XI. RESPONSE TO COMMENTS ON 2011 RECIRCULATED DRAFT EIR

This chapter of the Final EIR presents copies of all of the comment letters received on the 2011 Recirculated Draft EIR (RDEIR). A total of 16 comment letters were received on the RDEIR. The comment letters contained approximately 470 comments. The comment letters have been numbered and given written responses. This volume has been broken down into three sections.

Inspection Report Photos: Cold Canyon Landfill, March 29, 2011

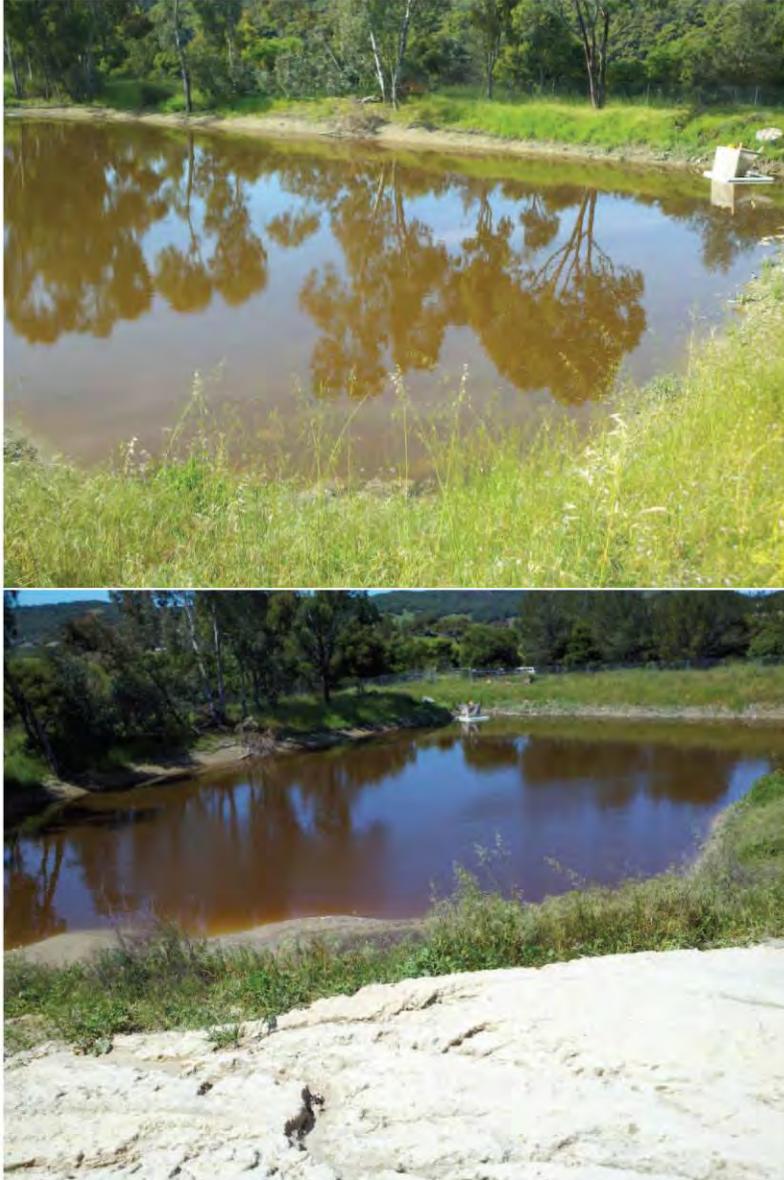
Photo 1 (top) & 2 (bottom) – Main Sediment Retention Pond: Pond has a tea brown color and is discharging (1-3 GPM). Discussed sampling the ponds discharge per the February NOV and that seeps observed onsite were low flow and appeared manageable. Since it had been several days since rain, containment measures should have been implemented to reduce impacts to the sediment retention pond and offsite discharge. **Violation:** WDR Specification C.12 requires the discharger to correct leachate seeps, which threaten the containment of the landfill, promptly. Directed landfill staff to implement seep containment measures. (Also see photos 5, 6, 7, and 10.)

Inspection Report Photos: Cold Canyon Landfill, March 29, 2011

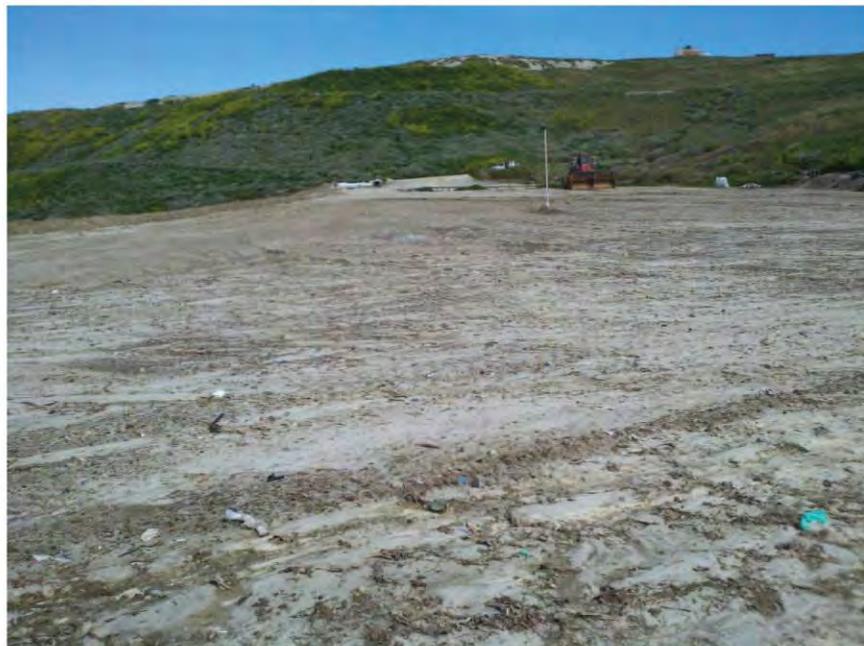
Photo 18 & 19 – Dry Weather Active Area Top Deck: Top deck is well graded and free of wind blown trash. Minor rilling observed on newer slopes but no trash is exposed. In general intermediate cover soils appear to erode easily and fines are observed at the bottoms of the non-vegetated slopes.

Inspection Report Photos: Cold Canyon Landfill, March 29, 2011

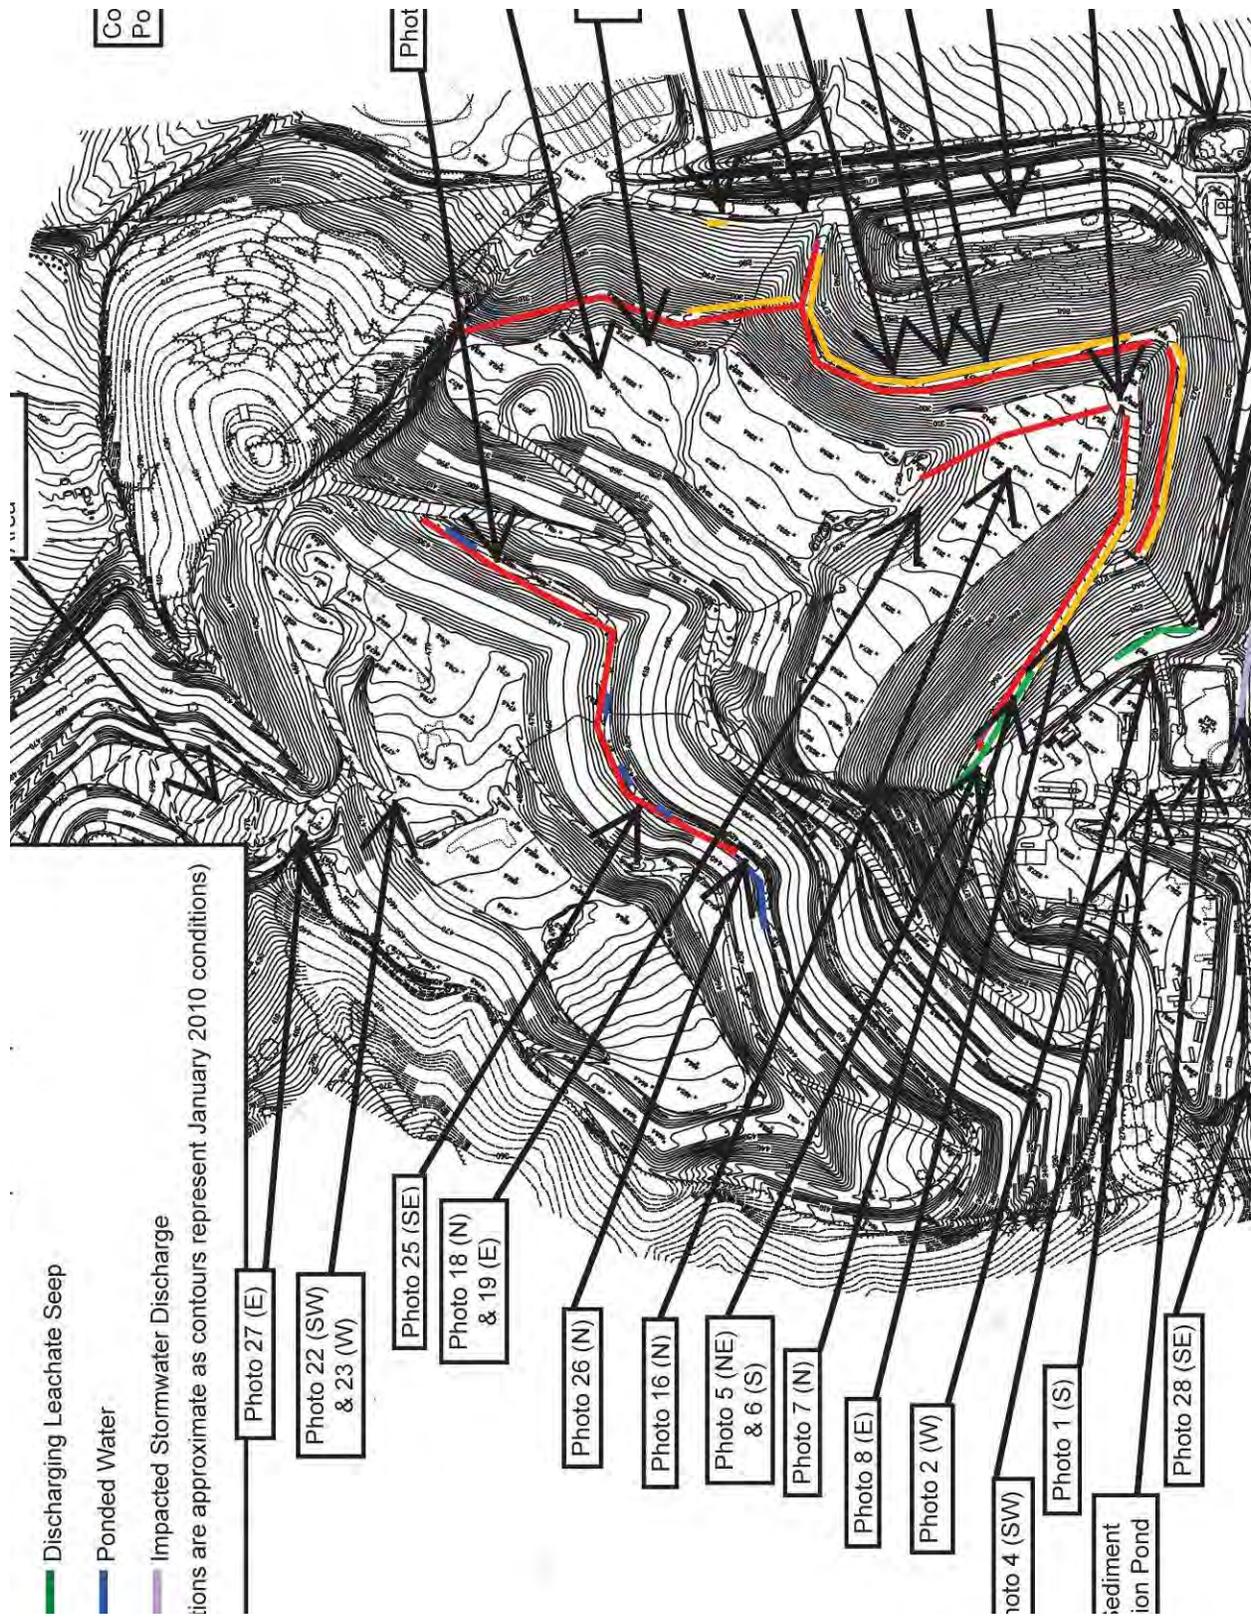
Photo 27 – Soil Stockpile: As noted during the March 21, 2011 inspection, chipped wood functioned well for erosion control but unexpectedly impacted runoff with a dark brown tea color. Due to the tea impacts landfill staff do not intend to continue using chipped wood for erosion control.
